## STAFF REPORT

**ITEM:** **Bentley Village** – Zoning Map Amendment, Easement Vacations and Preliminary Plat

Re: Bentley Village  
Preliminary Plan Engineering Review

TYPICAL TOWNHOME LOT DETAIL

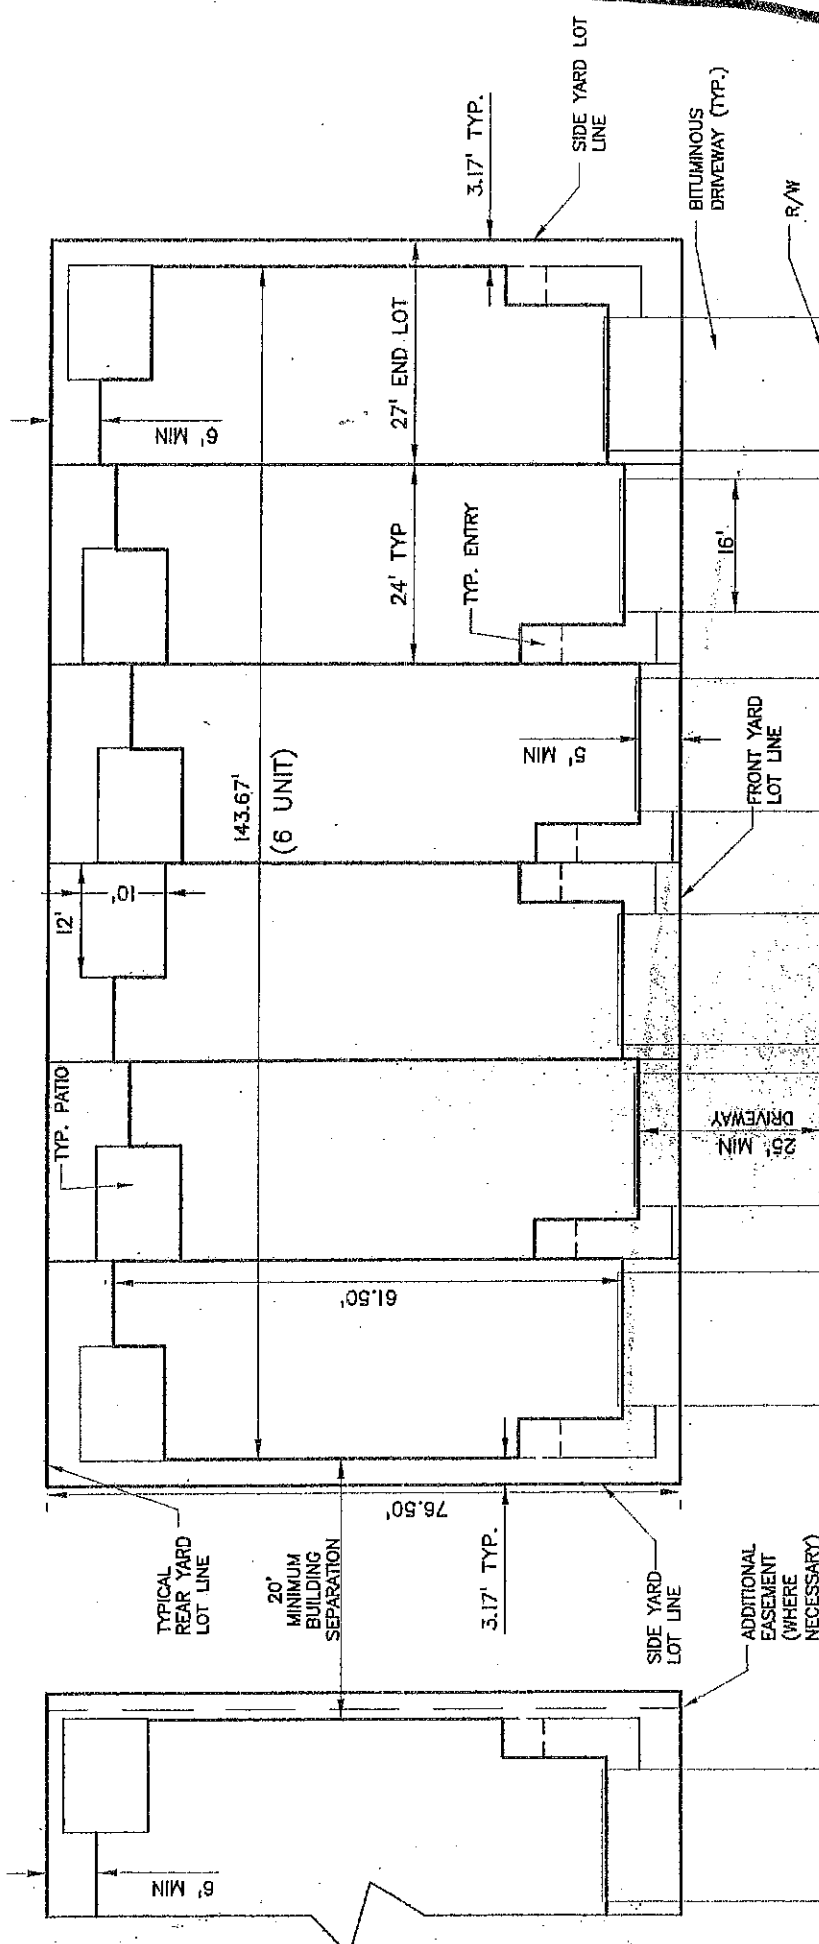
The project plans are not clear in showing that all of the proposed buildings and lots would meet all the required setbacks. Staff has included a detail from Sheet 7 of the project plans that has a typical townhome lot layout showing the proposed lot lines and the building placement. However, staff has identified several locations where it appears that corners of the proposed townhouses (or their patios) might encroach into required setbacks and/or easements or would be too close together to meet the City's 30-foot-spacing requirement to accommodate underground utilities (including storm sewer). These include:

- Typical Townhome Lot Detail. The typical Townhome Lot detail proposes a minimum setback of 25 feet from the right-of-way to the garage door. Preliminary Plat approval should identify this requirement as a condition of approval to ensure that vehicles parked in the driveway do not obstruct sidewalks.

27. That all garage doors be setback at least 25 feet from the street right-of-way to provide off street parking on the driveway to allow vehicle parking without blocking a public sidewalk.
